Amendment No. 0007  
13 December 2002

SUBJECT: Amendment No. 0007 to Specifications and Drawings for Construction of  
FY 03 DINING FACILITY, PN 054511, FORT CARSON, COLORADO.  
Solicitation No. DACA45 02 B 0011.

### CORNER REVEAL DETAIL

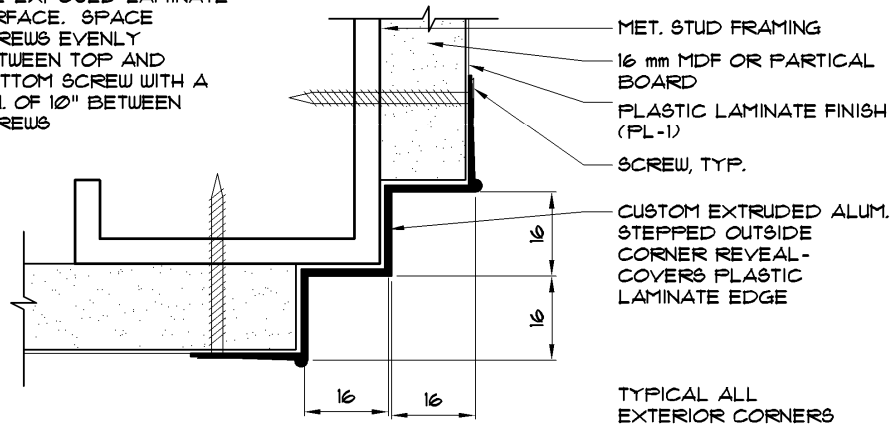
(a) Sheet A703, CORNER REVEAL DETAIL 10, revise detail in accordance with attached Sketch SD04.

PREDRILL HOLES TO  
ACCEPT SCREWS.  
SCREWS TO BE LOCATED  
2" FROM TOP OF  
LAMINATE SURFACE AND  
2" FROM THE BOTTOM OF  
THE EXPOSED LAMINATE  
SURFACE. SPACE  
SCREWS EVENLY  
BETWEEN TOP AND  
BOTTOM SCREW WITH A  
MIN. OF 10" BETWEEN  
SCREWS
